RECORD OF DECISION AMENDMENT

ANACONDA REGIONAL WATER, WASTE, AND SOILS OPERABLE UNIT

Anaconda Smelter National Priorities List Site
Anaconda – Deer Lodge County, Montana

September 2011

Figure 3-1. Revised Ground Water Area of Concern
Anaconda Regional Water, Waste, & Soils OU
Anaconda Smelter NPL Site, Montana

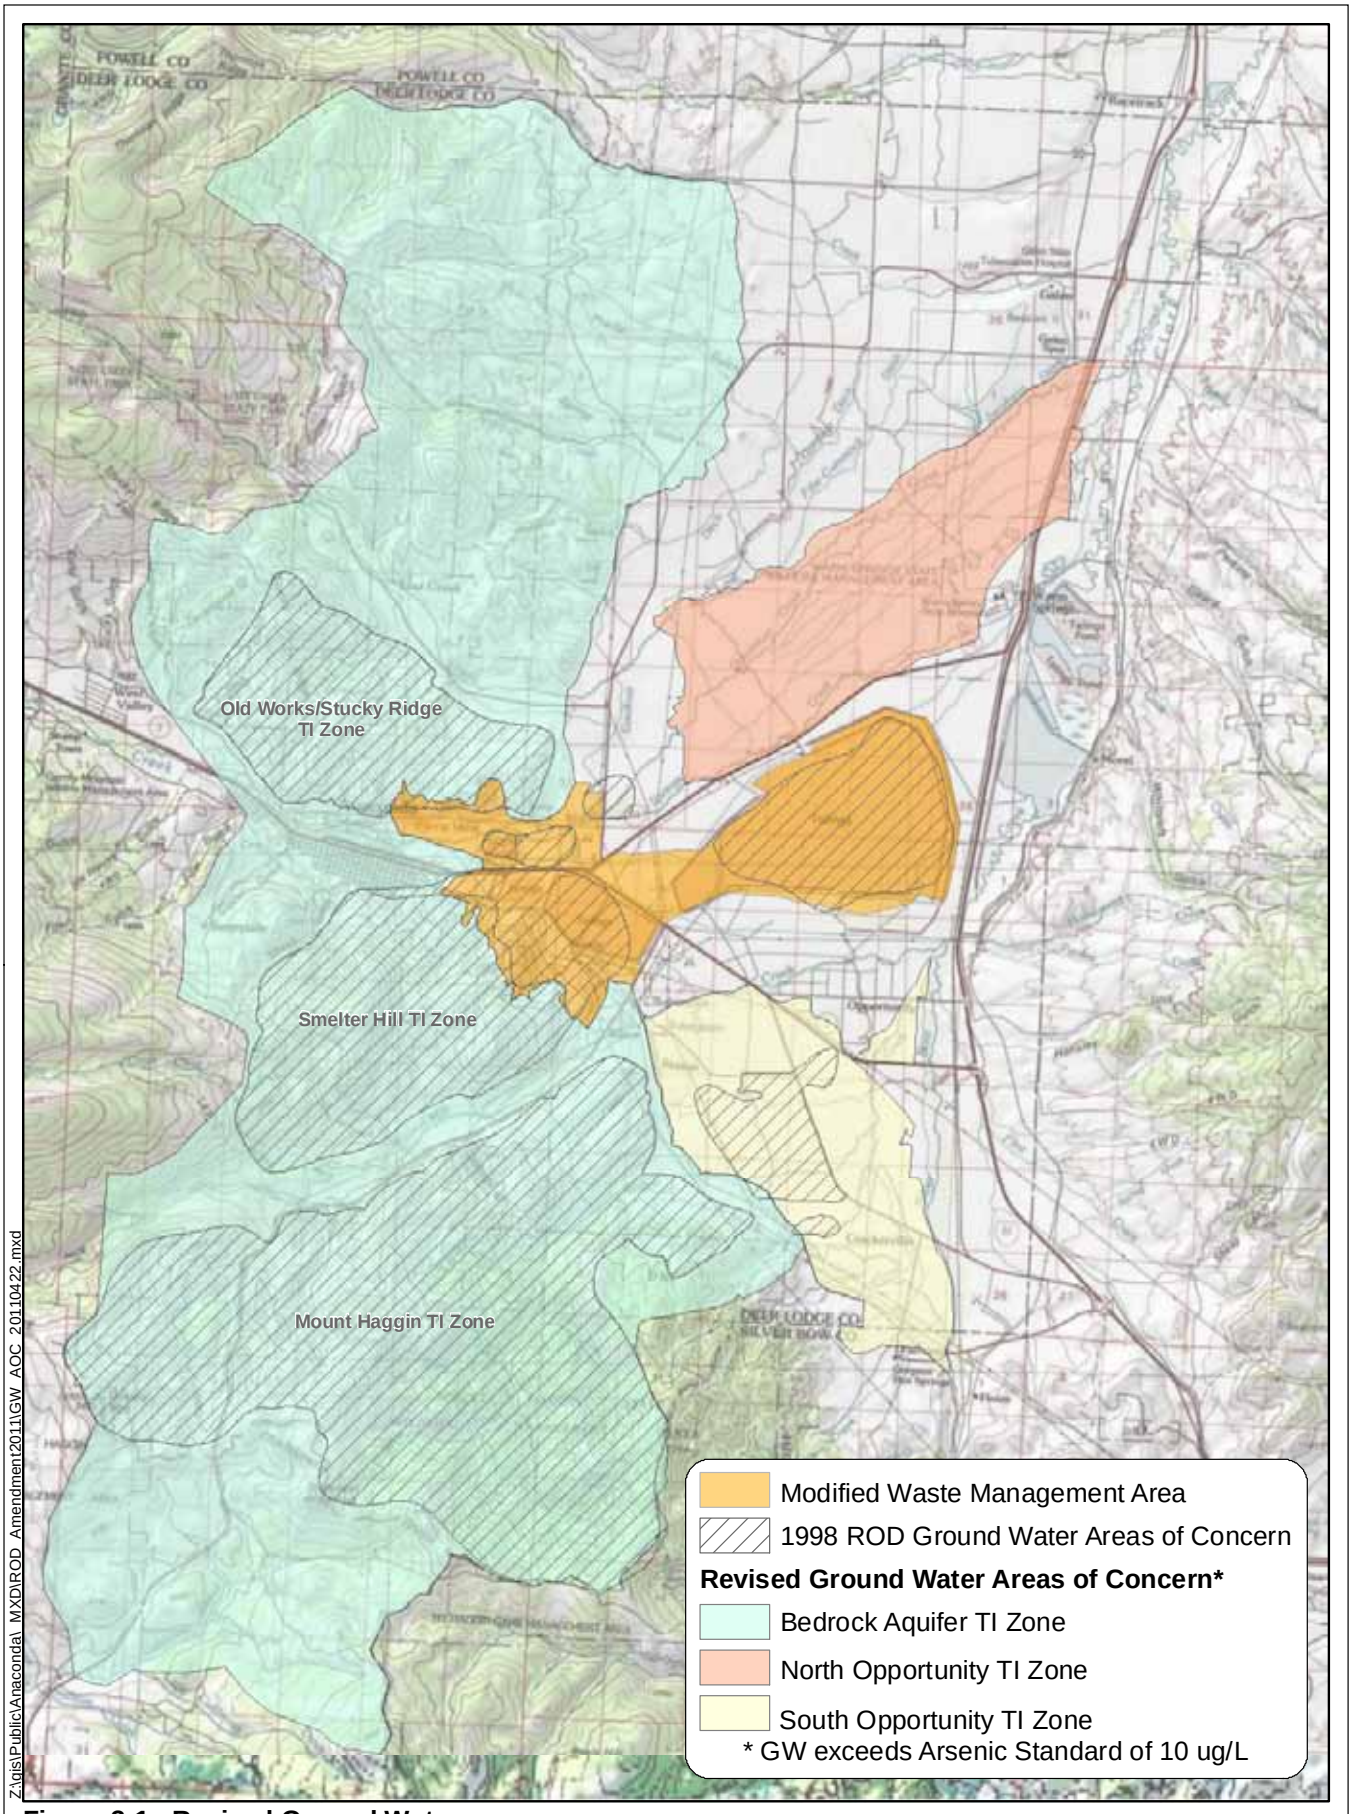
The 1998 ROD identified ground water areas of concern based on the existing arsenic RAG and site characterization at the time. Lowering the arsenic standard concentration to 10 µg/L has resulted in a significant increase in the size of the contaminant plume. In addition to the change in the standard, additional site characterization data collected during RD has resulted in better definition of areas of contamination. These investigations include spring and seep sampling in the uplands and wetland areas, installation of monitoring wells in the bedrock aquifer TI zone and around the waste management areas, and installation of piezometers in alluvial aquifer areas of concern. Figure 3-1 compares the new ground water area of concern

Figure 3-2. Revised Surface Water Area of Concern
Anaconda Regional Water, Waste, & Soils OU
Anaconda Smelter NPL Site, Montana

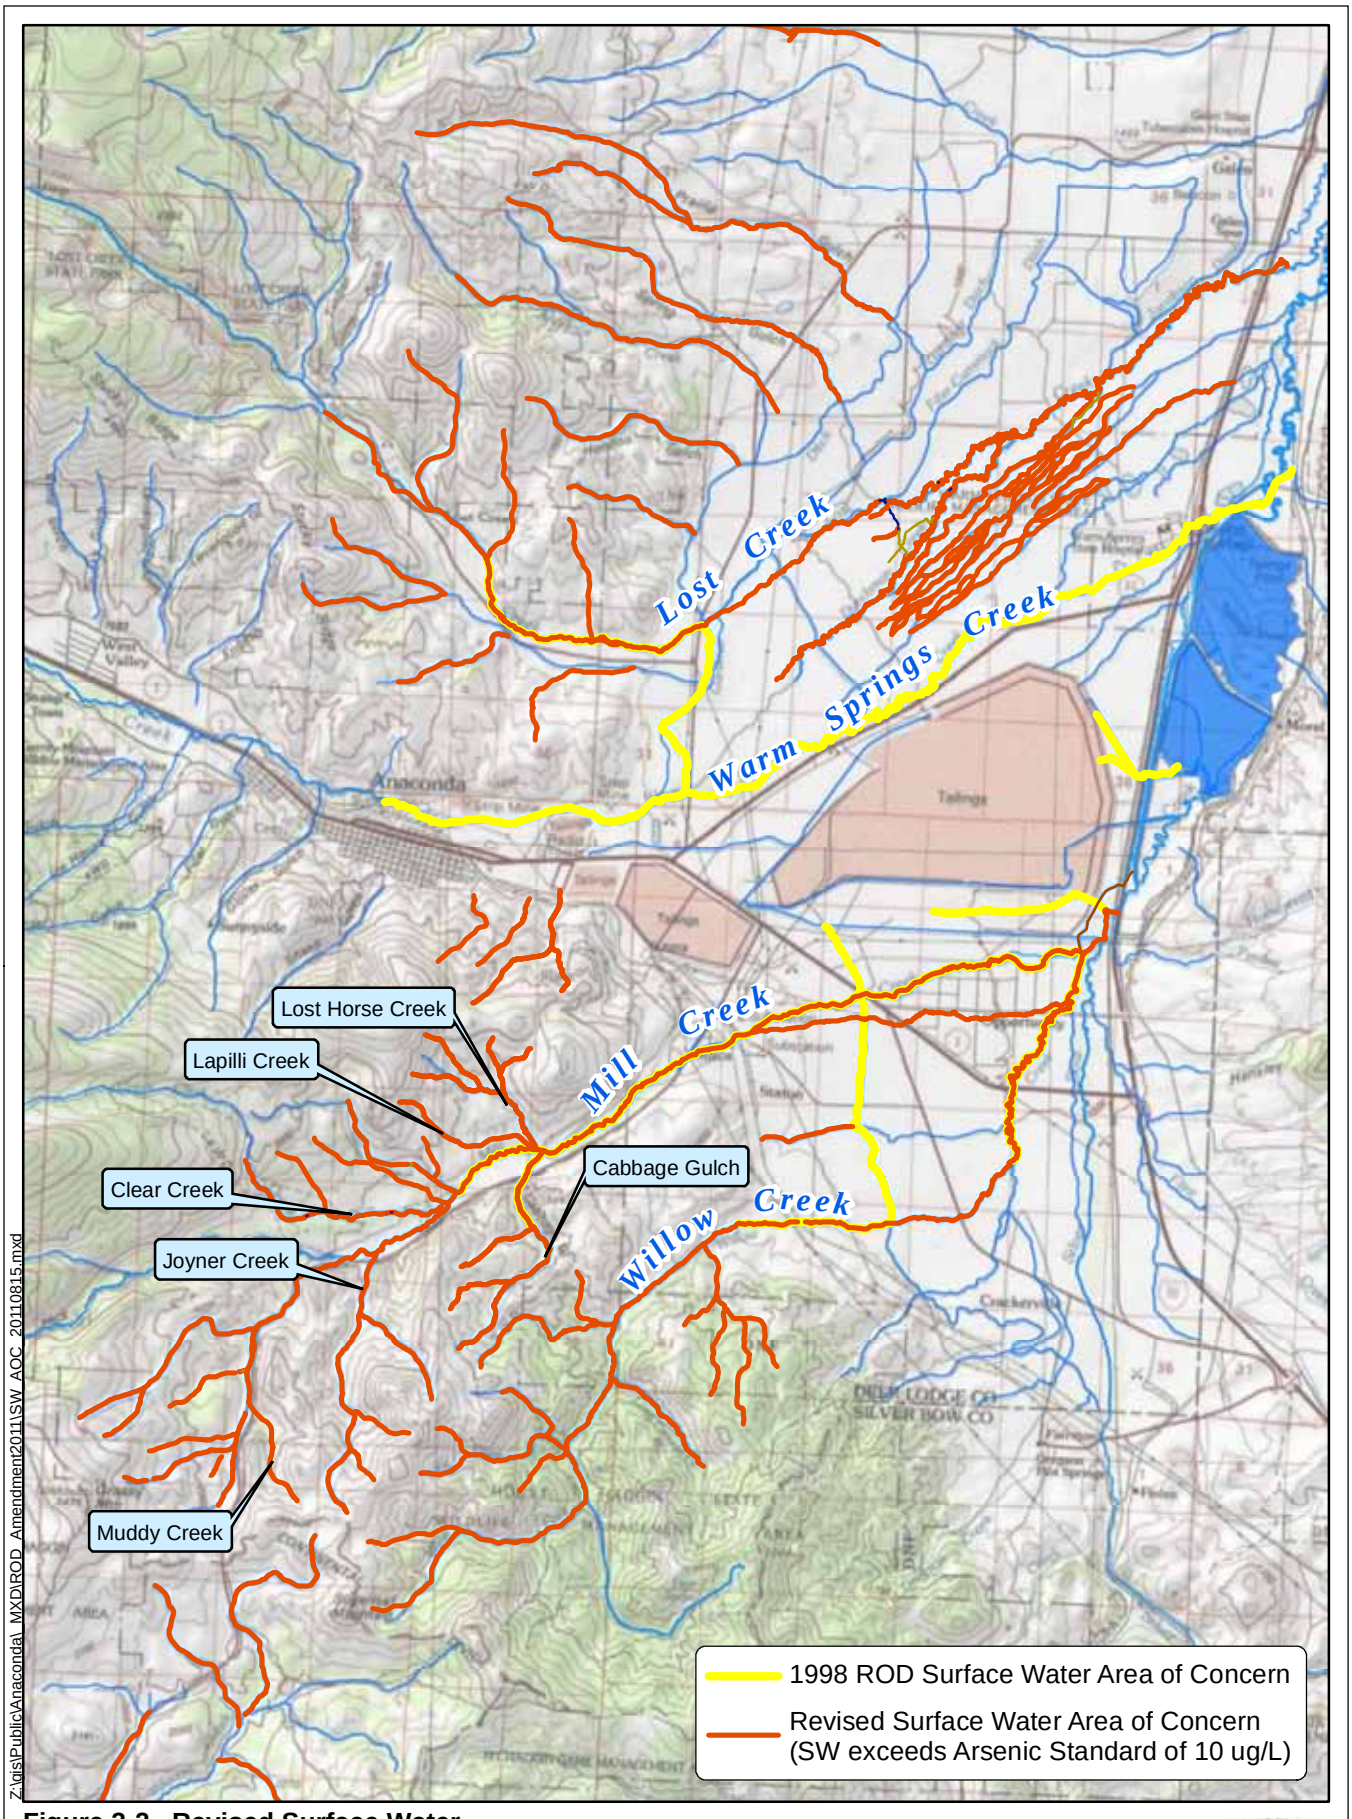
The 1998 ROD identified surface water (stream reach) areas of concern. These reaches were identified based on arsenic concentrations exceeding the 1998 human health quality standard of 18 mg/L, and copper exceedance of aquatic life criteria in areas impacted by uplands storm water runoff or erosion of fluvially-deposited tailings. Additional sampling of surface water during RD, together with the new arsenic human health standard, has led to the identification of a surface water area of concern based on exceedances of the human health standard. Figure 3-2 displays the new arsenic exceedance-based surface water area of concern in addition to the areas identified in the 1998 ROD.

Figure 3-3. Waste Management Areas

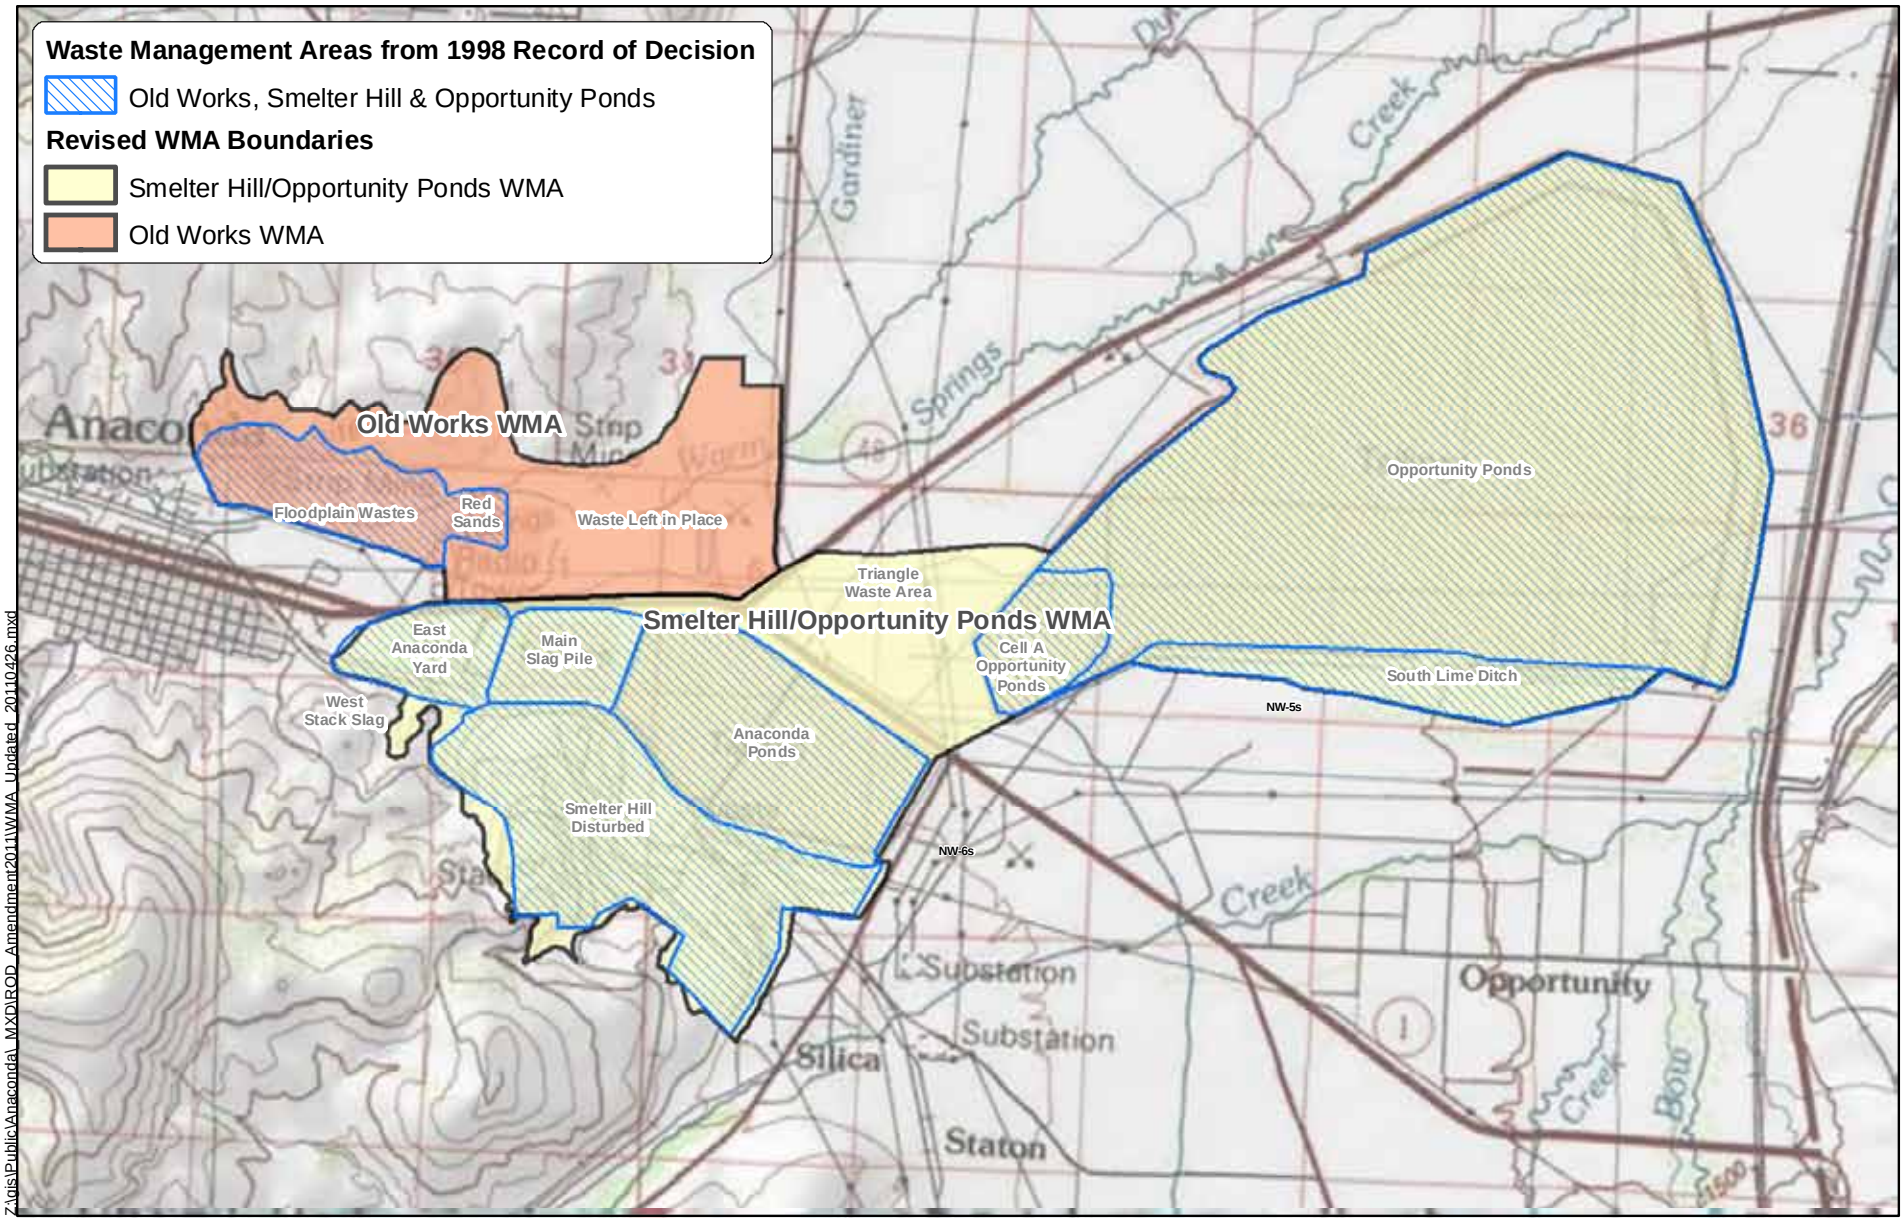
The changes result in the Old Works WMA and Old Works Wastes Left-In-Place being merged into a larger Old Works WMA; and the Triangle Waste area being merged into the Opportunity Ponds WMA. Additional modifications to the WMA boundaries include adding the West Stack Slag to the Smelter Hill WMA and the merging of the Smelter Hill WMA and Opportunity Ponds WMA into one WMA. Rationale for these further changes is set forth below in Sections 4.1 and 8.1. Figure 3-3 compares the new WMA designations to the WMAs identified in the 1998 ROD.

Figure 3-4. Soils Areas of Concern and High Arsenic Areas

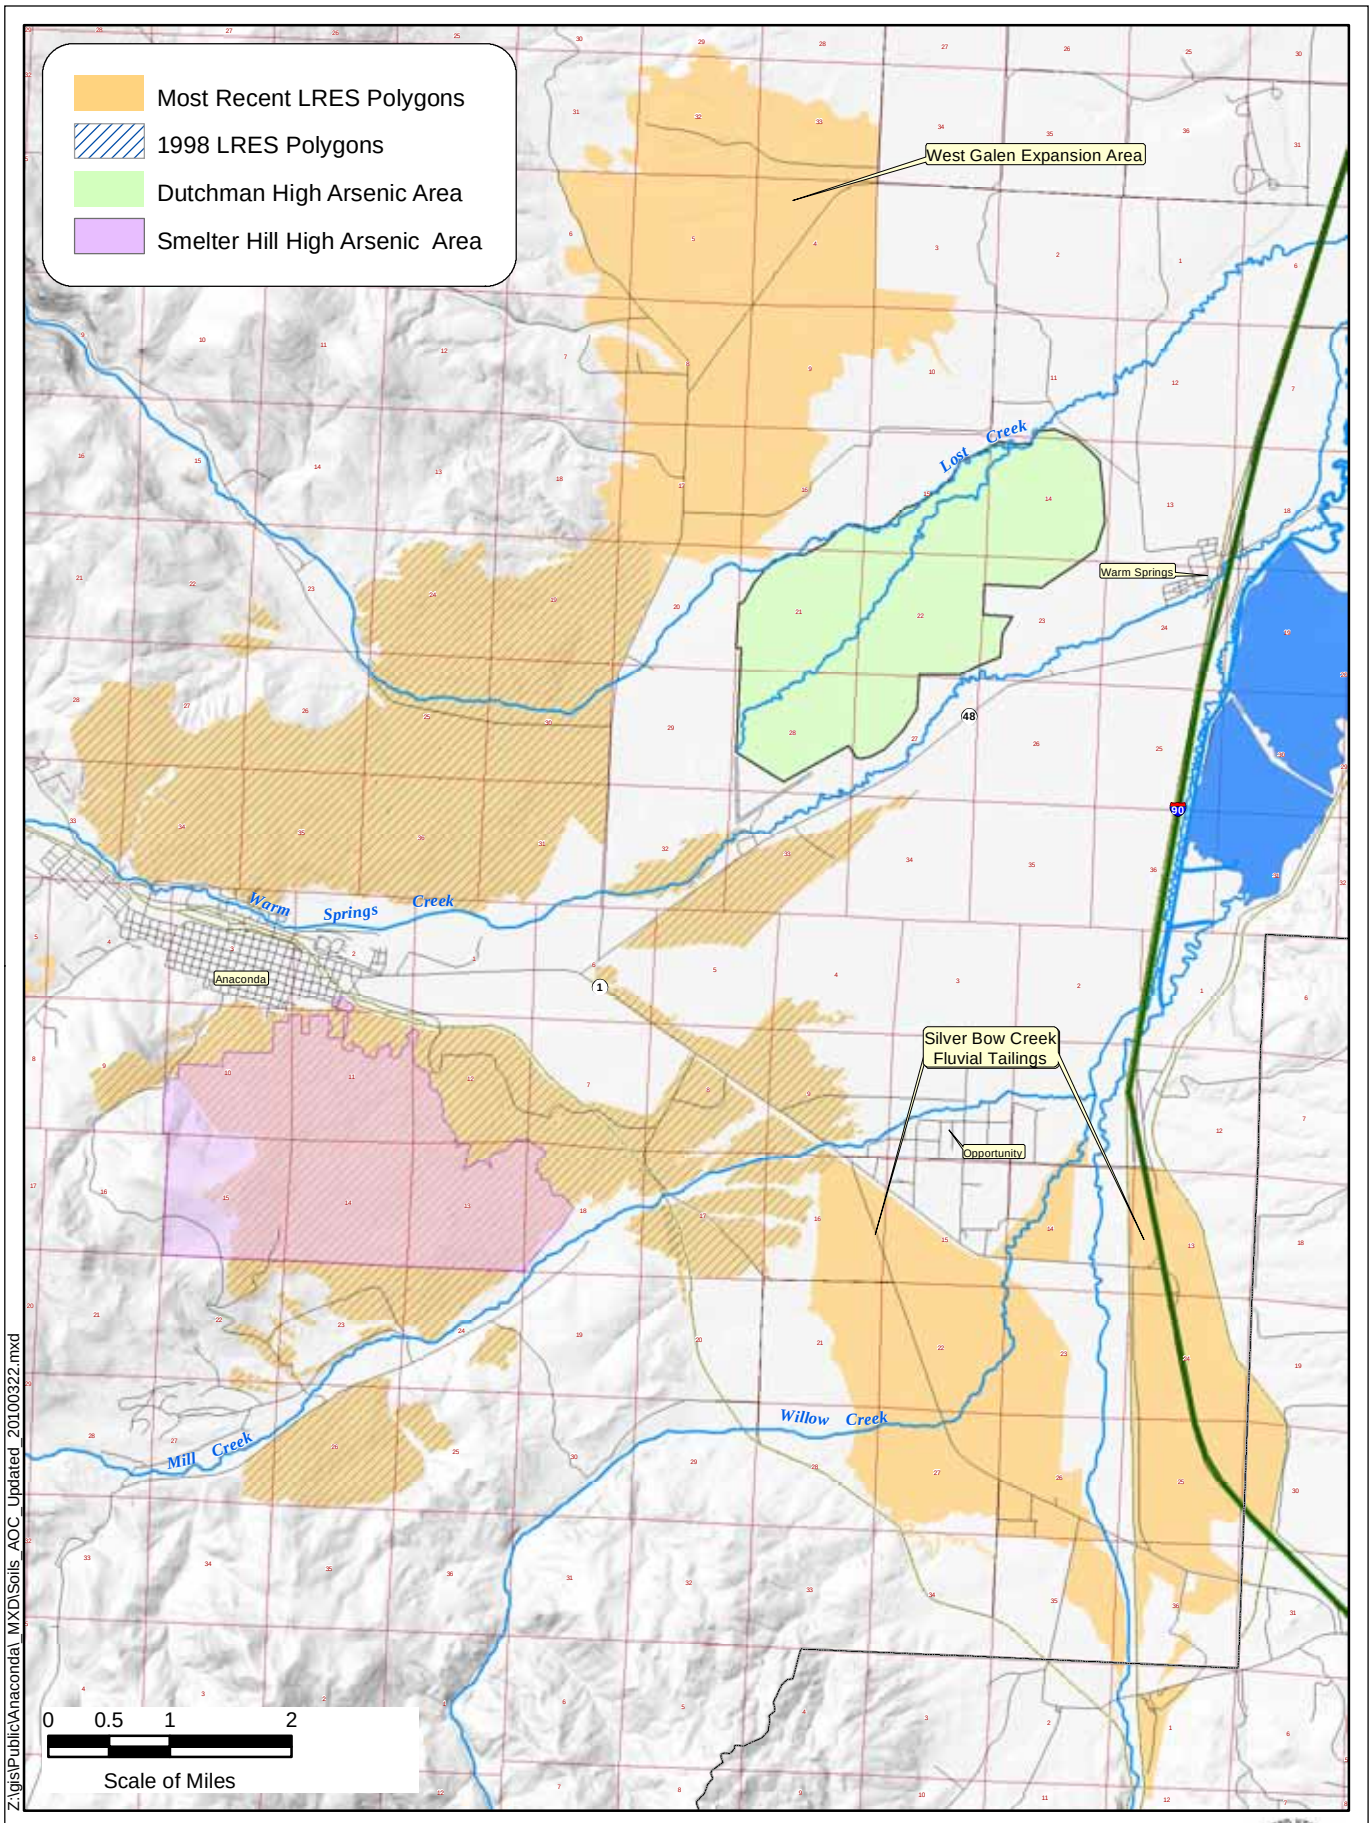
Figure 3-4 shows the 1998 LRES polygons and the 2011 ROD Amendment soils area of concern. As shown on Figure 3-4, new soil areas of concern were identified in the West Galen area, and near Silver Bow Creek outside of the Streamside Tailings OU of the Silver Bow Creek/Butte Area NPL Site boundary. RDU 9 Silver Bow Creek Fluvial Tailings is discussed in Section 6, while the West Galen Expansion Area is discussed in Section 7. HAAs delineated in the Dutchman and Smelter Hill areas are discussed in Sections 5 and 8, respectively.
